STAFF REPORT

SUBJECT:	PRS 21-0311	PLANNING AREA:	Brandon
REQUEST:	Minor Modification to an Approved PD	SECTOR	Central
APPLICANT:	Lennar Homes, LLC		
Existing Zoning: PD 89-0206		Comp Plan Category: RM	U-35, UMU-20

Application Review Summary and Recommendation

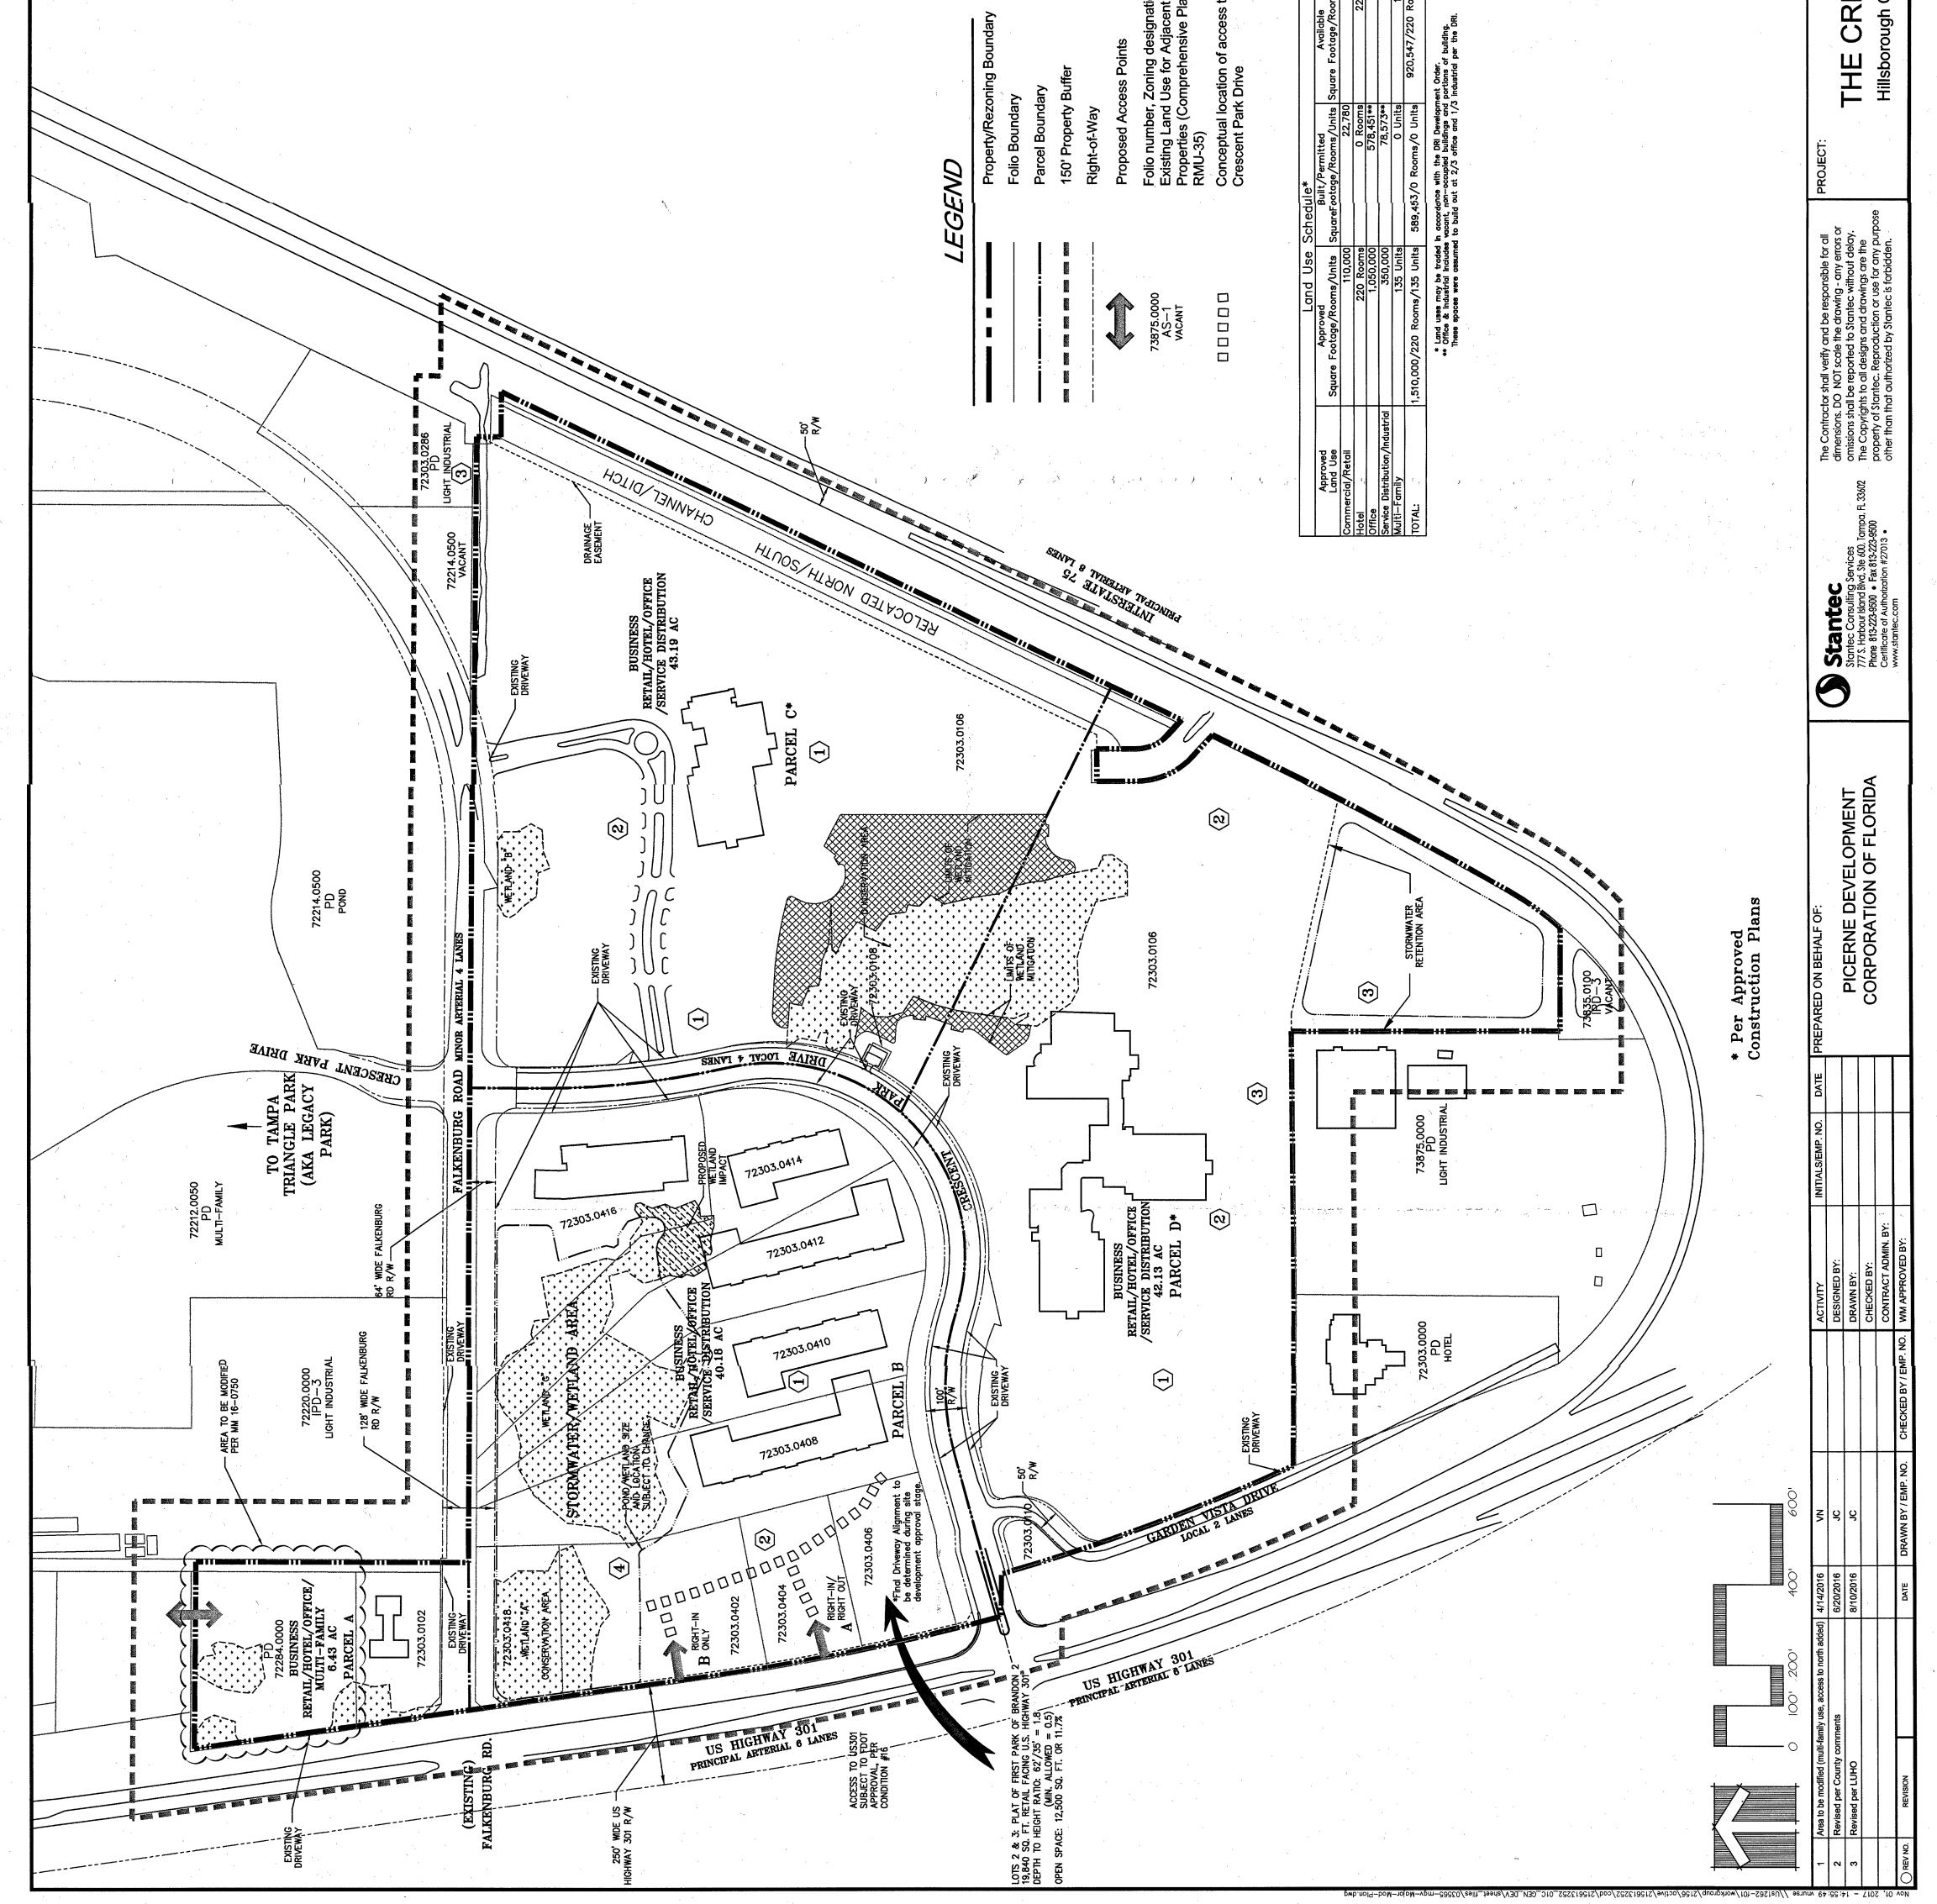
• Prior to PD Site Plan Certification, the developer shall revise the site plan to:

- Modify Note 5 to add "Bicycle parking shall be provided pursuant to Section 3.02.04 of the LDC, which shall reduce the aforementioned minimum vehicle parking requirements as provided for within Section 3.02.04.S.4. of the LDC". [Staff is proposing this modification to clarify there are multiple forms of required parking, and that the 6.05 parking minimums shall be reduced in accordance with the above referenced section].

- Delete Note 14. [*This topic is more appropriately included as a zoning condition. Staff has proposed a modification to existing condition 32 to accomplish this, as well as provide additional language to comport with current practice and clarify expectations with regards to developer submittals, how equivalency must be calculated, and resulting staff review and outcomes.*]

- Modify Note 17 to read, "Number and location of driveway cuts are subject to change on future subdivision/development of property to the extent permitted within the approved zoning conditions." [Staff notes there are specific conditions in the existing PD regarding number of access points on certain roadways, and a notation on the PD site plan should not set up a conflict with those provisions. Additionally, PDs are site plan-controlled zoning districts, so generally a higher level of control is required (except as has been previously authorized).]
